INSTRUCTION TO SERVICE

ITS60378		March 23, 2022
SECTION:	292-Electrical Harness	
WRITTEN BY:	Aditya Gadepalli	
SUBJECT:	Alternator Ring Terminal Rework	
ISSUE:	The ring terminal connected to the indicator light terminal on the back of the Delco alternator could be corroded and cause intermittent issues.	
SUMMARY:	Changing the ring terminal to a more weather friendly part on the indicator light terminal will either resolve or prevent the intermittent issue. This ITS provides the steps to discard the existing terminal and crimp a new better version terminal.

ITS60378

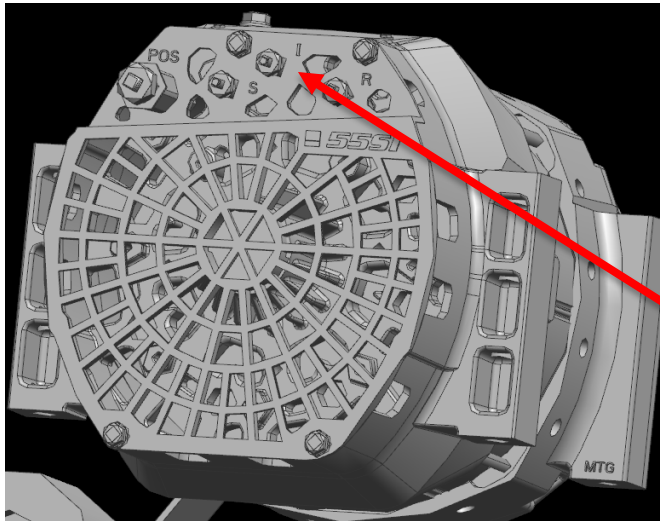
4. Locate wire ID 0208 behind the top alternator connected to the stud "I". Remove and save the nut securing the wire.
5. Cut and discard the ring terminal on wire 0208.

Cut the ring terminal on wire ID 0208 connected to stud "I"

6. Crimp 4" of 18 AWG black wire, MCI P/N: 19-11-1251, to the 0208 wire using splice connector, MCI P/N: 19-11-3775, and heatshrink, MCI P/N: 19-11-1465.

Crimp 4" black wire using splice connector and heatshrink

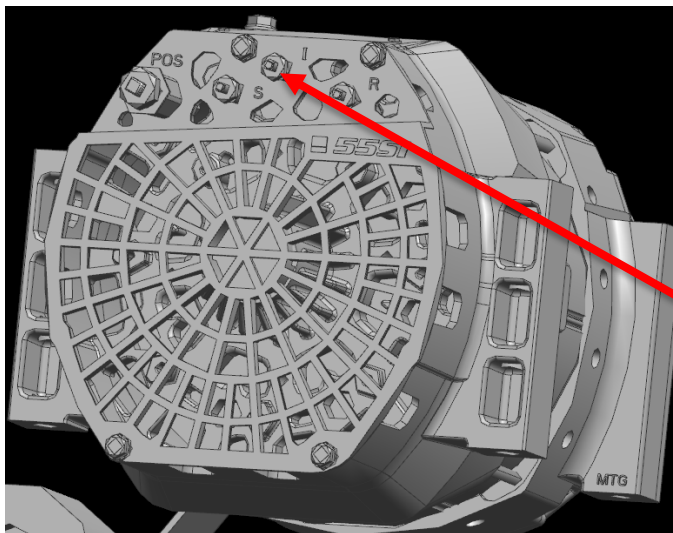
7. Crimp #10 ring terminal, MCI P/N: 19-11-402, to the other end of the added wire using heatshrink, MCI P/N: 19-11-1465.

Crimp #10 ring terminal using heatshrink

8. Re-install the modified 0208 wire to the "I" stud using existing hardware and torque the nut to 15-25 In-Lbs.

Connect the modified wire to stud "I" and torque to 15-25 In-Lbs

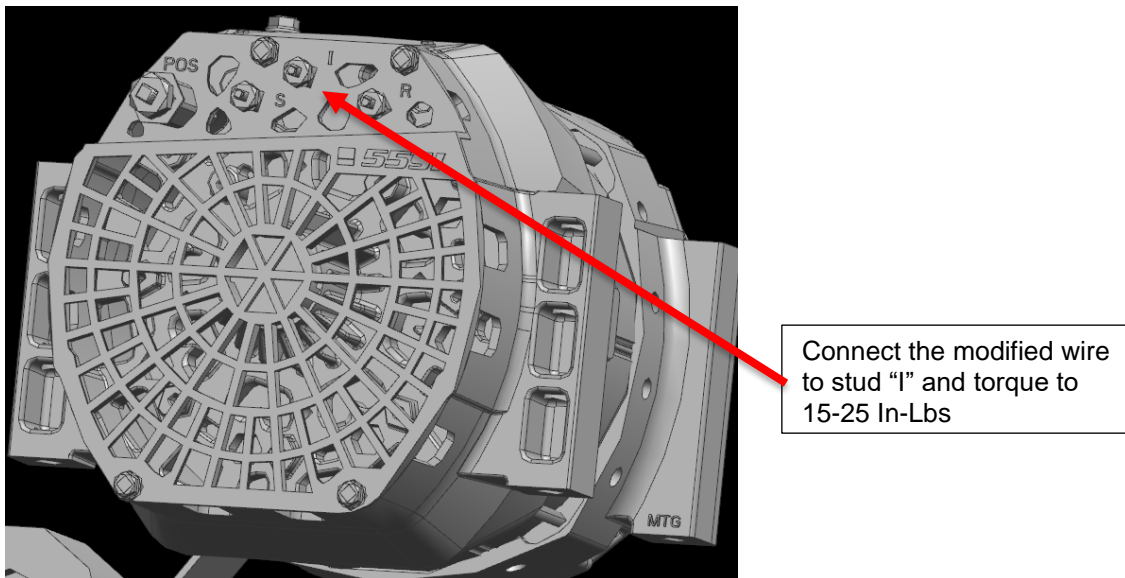
9. Locate wire ID 0207 behind the bottom alternator connected to the stud "I". Remove and save the nut securing the wire.
10. Cut and discard the ring terminal on wire 0207.

Cut the ring terminal on wire ID 0208 connected to stud "I"

11. Crimp 4" of 18 AWG black wire, MCI P/N: 19-11-1251, to the 0207 wire using splice connector, MCI P/N: 19-11-3775, and heatshrink, MCI P/N: 19-11-1465.

Crimp 4" black wire using splice connector and heatshrink

14. Wire Splicing Procedure

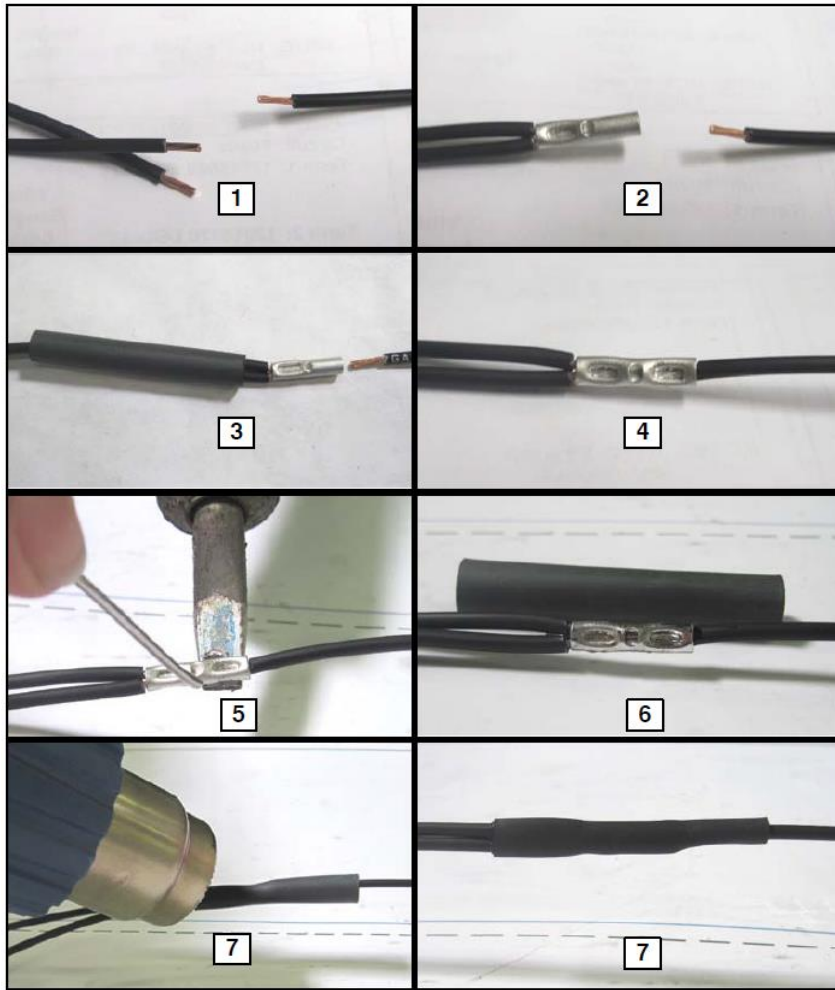
ITEM	DESCRIPTION
1	Using wire strippers, strip the wires 0.250 inch.
2	Crimp one wire.
3	Orient and slide the heatshrink over the crimped wire.
4	Crimp the other wire.
5	Solder the center of the crimp joint. Proceed to solder both ends.
6	Orient and center the heat shrink over the butt splice.
7	Using a heat gun, shrink down all the way until the melted glue is visible.

15. Ring Terminal Crimping and Sealing Procedure:

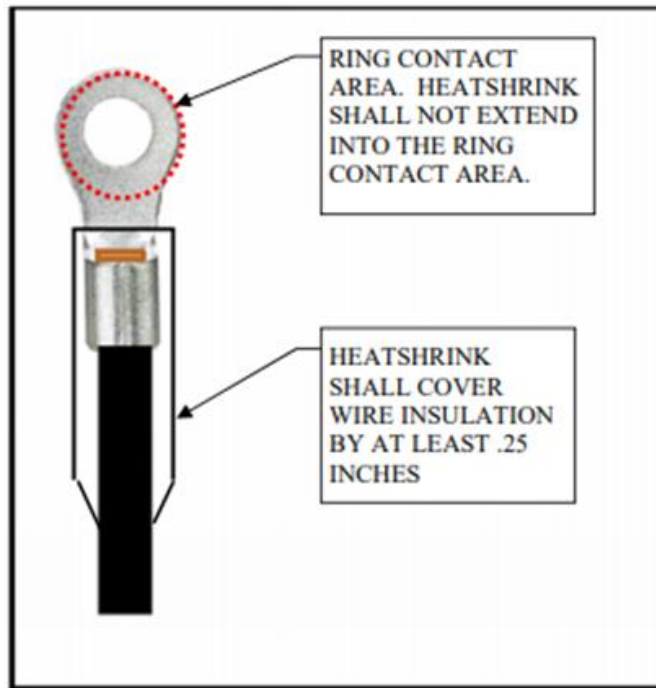
Ring terminal to be crimped, soldered and heat shrink applied as detailed below. The applied heat shrink for non-insulated terminal ends shall not extend into the ring contact area and shall cover wire insulation by at least .25 inches. The ring contact area is defined as the area within the outer terminal ring circumference shown by the red dotted circle in the figure below.
